REMARKS

Amendments to the Drawings:

Attachments: Replacement FIG.s 1-6

FIG. 1 (Prior Art)

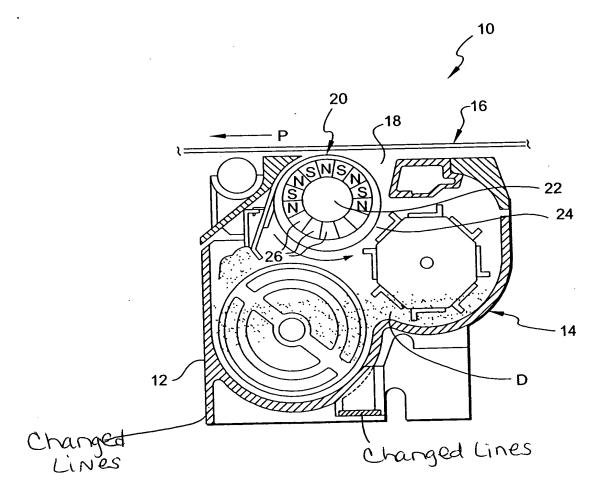
The Applicant has amended all the drawings as recommended by the Examiner in order to more closely follow the guidelines recommended in the MPEP. The words "Prior Art" have been added to FIG. 1 as the Examiner requested, the cross hatching for dielectric and the casing have been changed to that for a "conductive insulating material" and a "plastic" to more closely represent what is discussed in the specification. As always, the Examiner should reference the specification to better understand what this cross-hatching means since the MPEP definitions appear more limiting then we use in the specification.

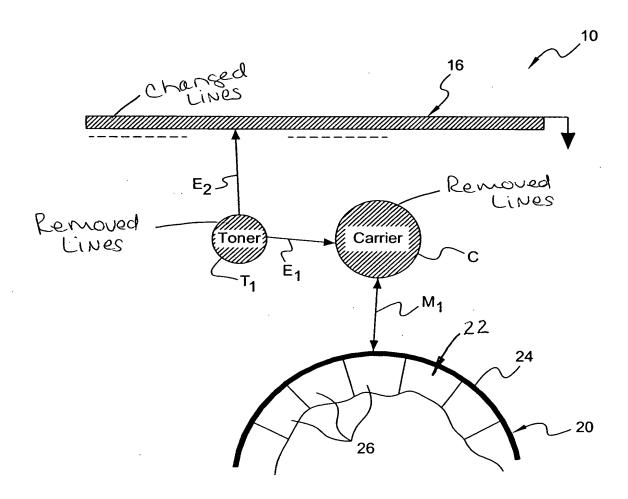
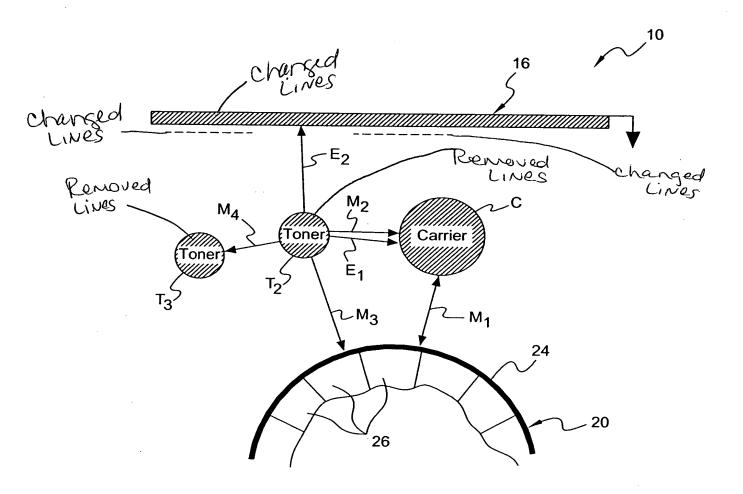
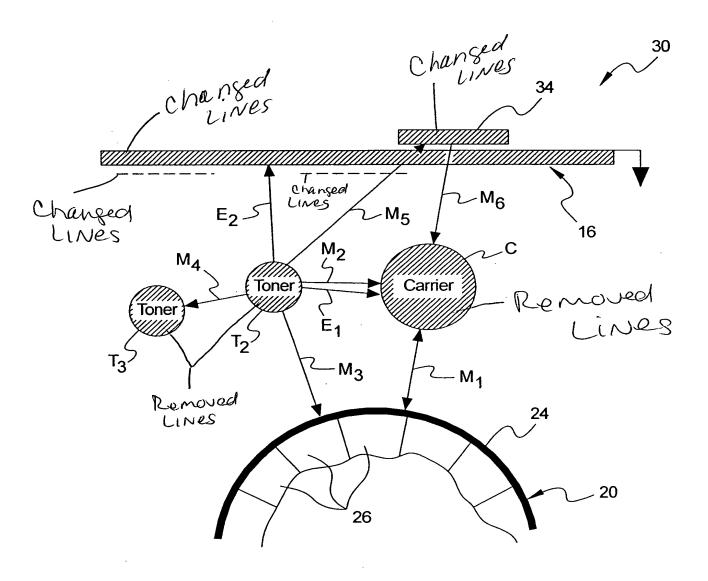
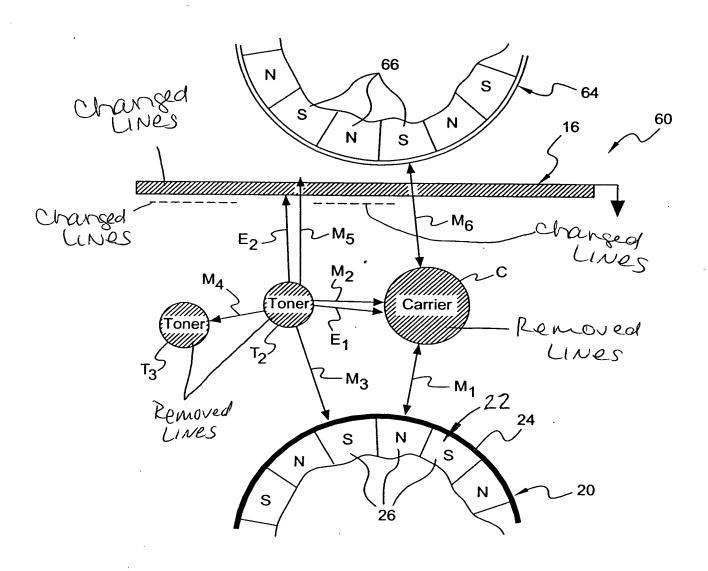
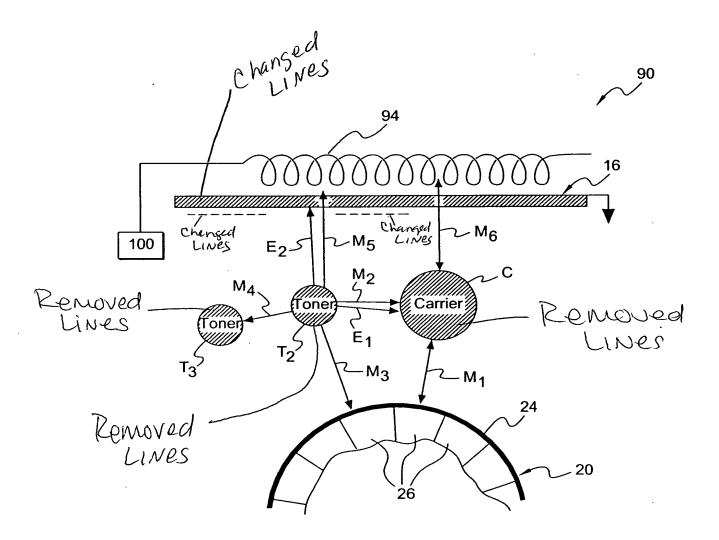
The attached sheets of drawings include changes to FIG.s 1-6. These sheets replace the originally submitted drawings for FIG.s 1-6, which incorporate the changes required by the Examiner. Approval by the Examiner is respectfully requested.
